P 35339
A REPAIR

SEWAGE DISPOSAL SYSTEM

HOWARD COUNTY
BUREAU OF ENVIRONMENTAL HEALTH
992-2330

SUBDIVISION Poplar Springs ROAD 1038 St. Michael's Road F

TITLE FINAL CERTIFICATION PLAT			
PROJECT LOT F - POPLAR SPRINGS SUBDIVISION			
LOCATION 4TH ELECTION DISTRICT HOWARD CO., MD.			
DATE: 10/11/77	DESIGN BY: -	DRAWN BY: W.H.N.	CHECKED BY: W.G.H.
SCALE: AS SHOWN	JOB NO.: 77214	DRAWING NO.: 1 OF 1

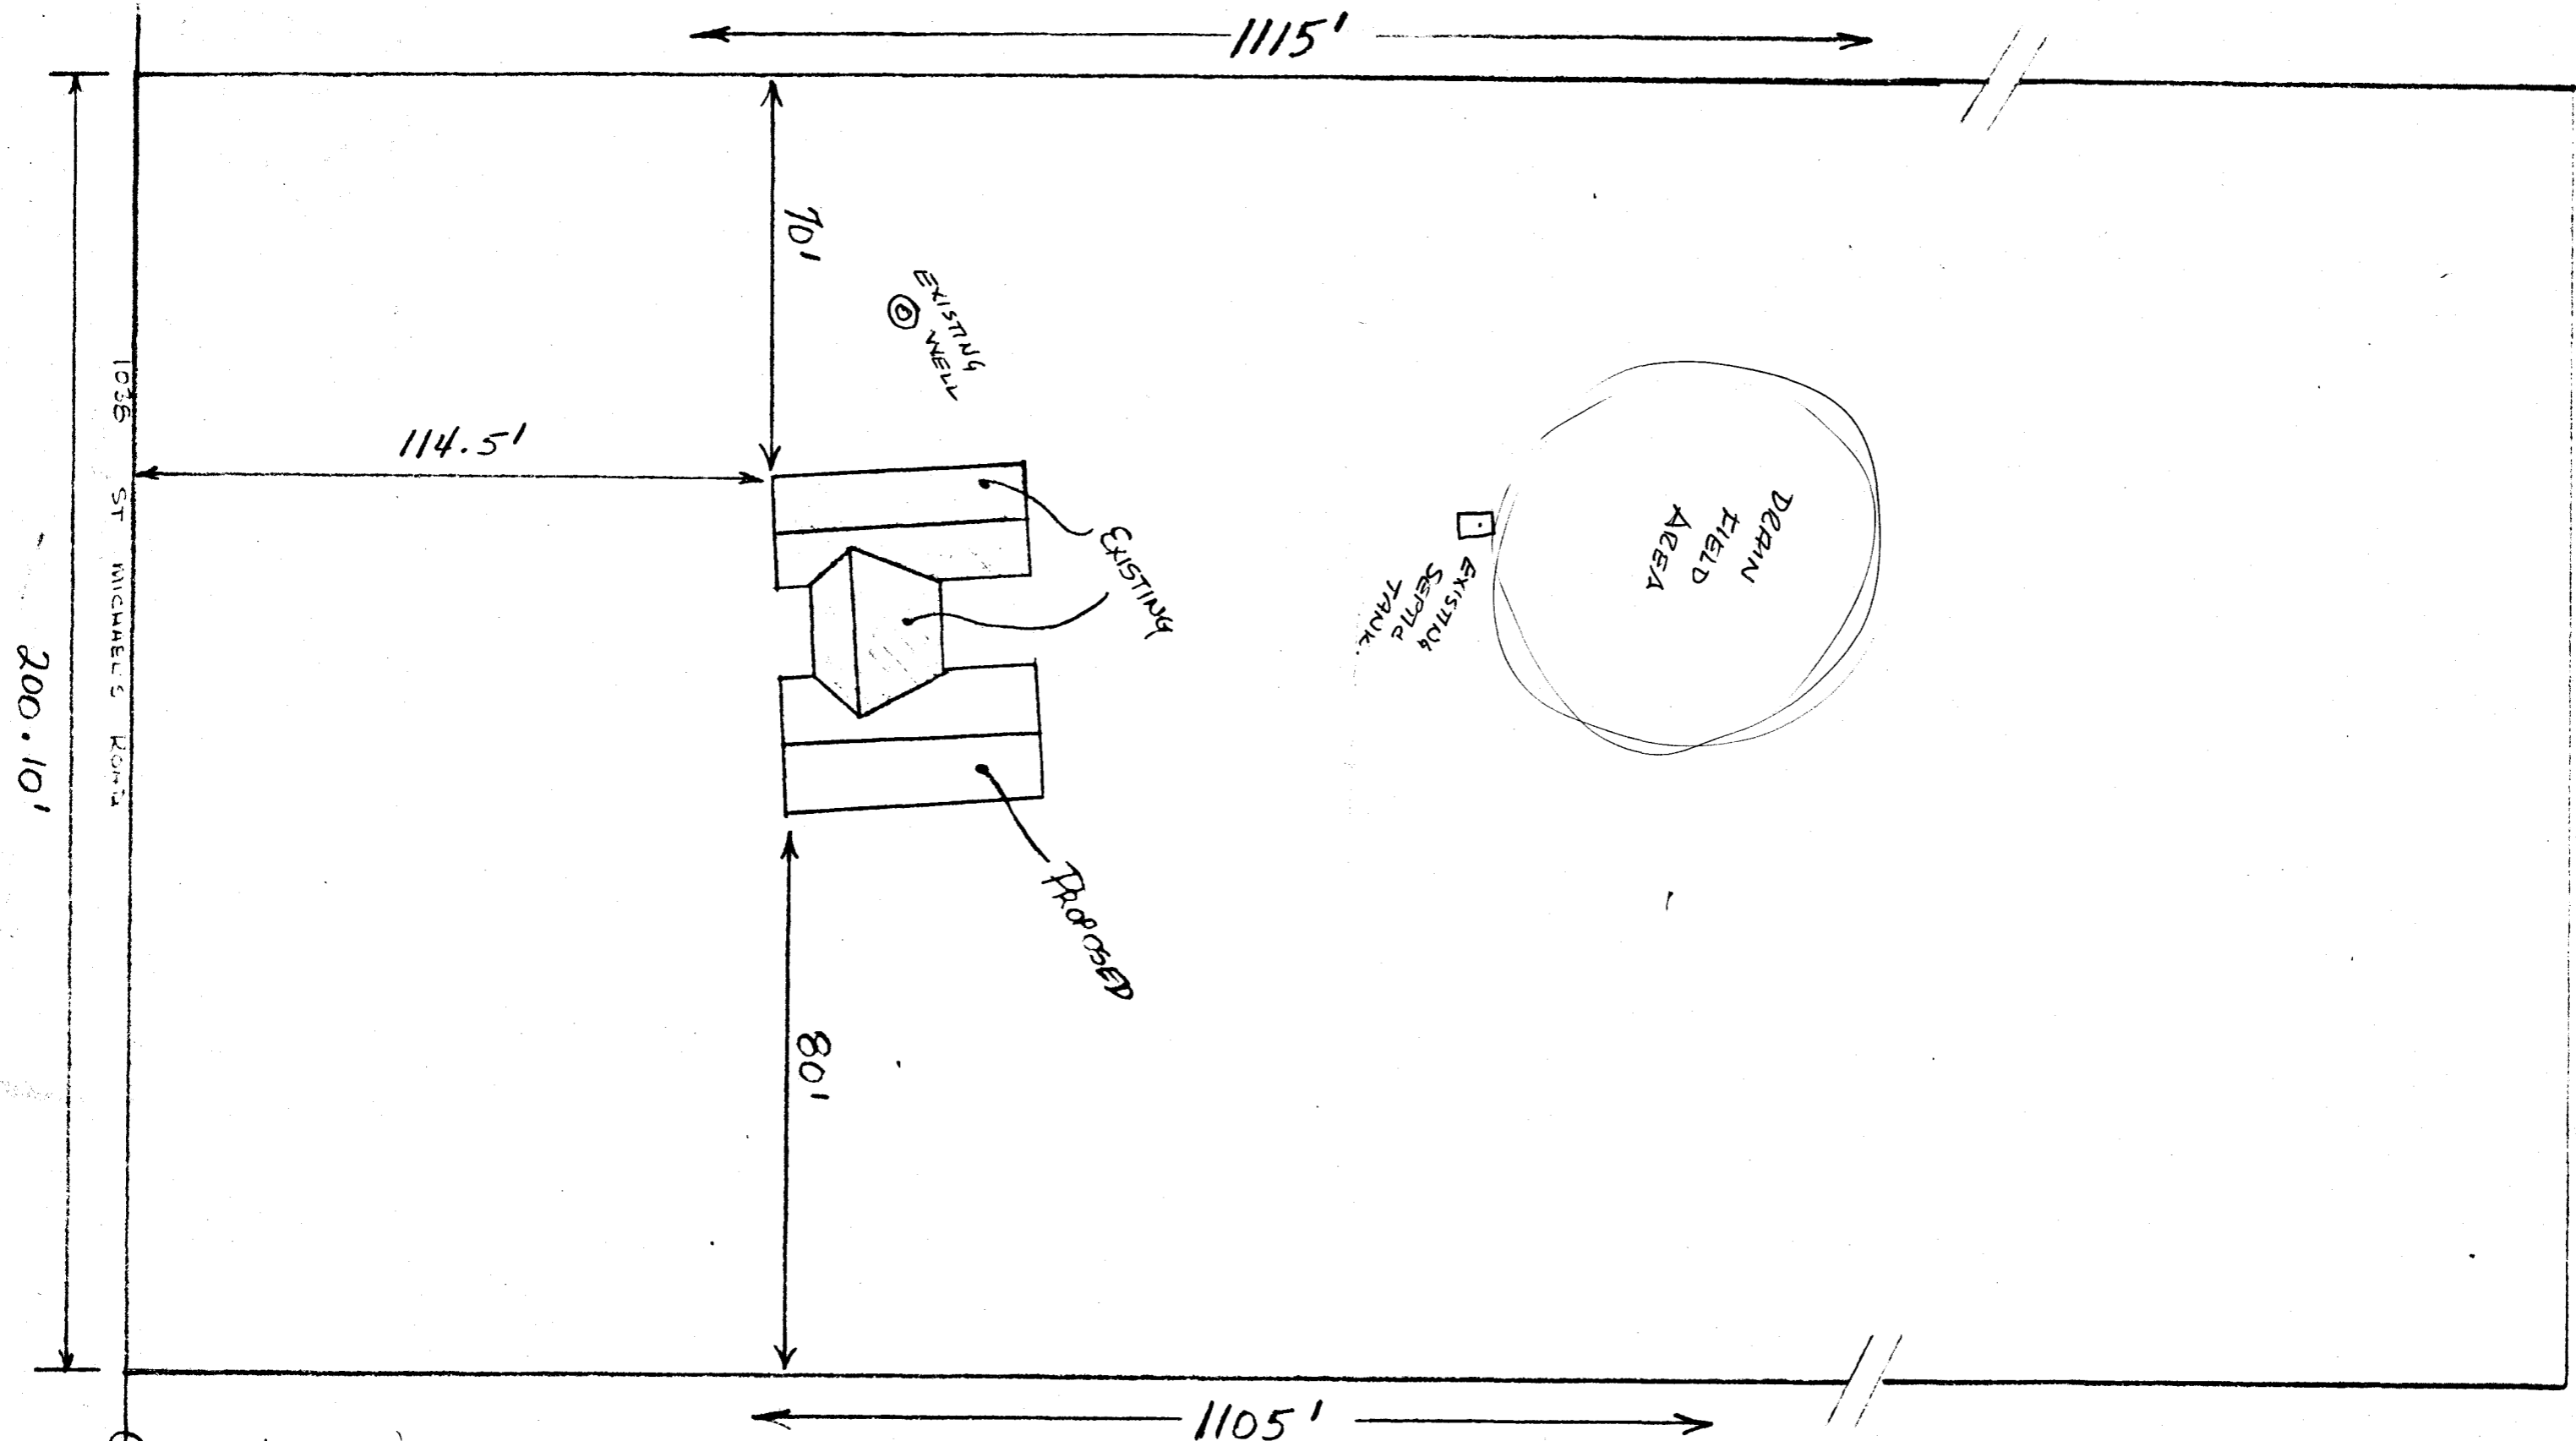
4-25-85 REPAIR PERC RESULTS - SOIL ACCEPTABLE FOR SYSTEM NO

DEEPER THAN 4 1/2' - CONSIDERABLE STRUCTURE SETTLEMENT BELOW 8'. CW

4/15/85 Recommended to Mr. O'Donnell they to get someone to take out
repair permit (indicated was boring system pumped regularly)
& upon inspection of soil (satisfactory) we could release
his permit J.F.

RECOMMEND - REPLACE EXISTING TANK WITH 1500 GAG. TANK

INSTALL MINIMUM OF 158' OF 3' WIDE TRENCH, INLET AT 3' BOTTOM NO DEEPER THAN 4 1/2'

TRENCH TO BE IN BACK YARD, 100' FROM ANY WELL AND PARALLEL TO ROAD.

ABANDON AND SEAL EXISTING SYSTEM. Craig Williams
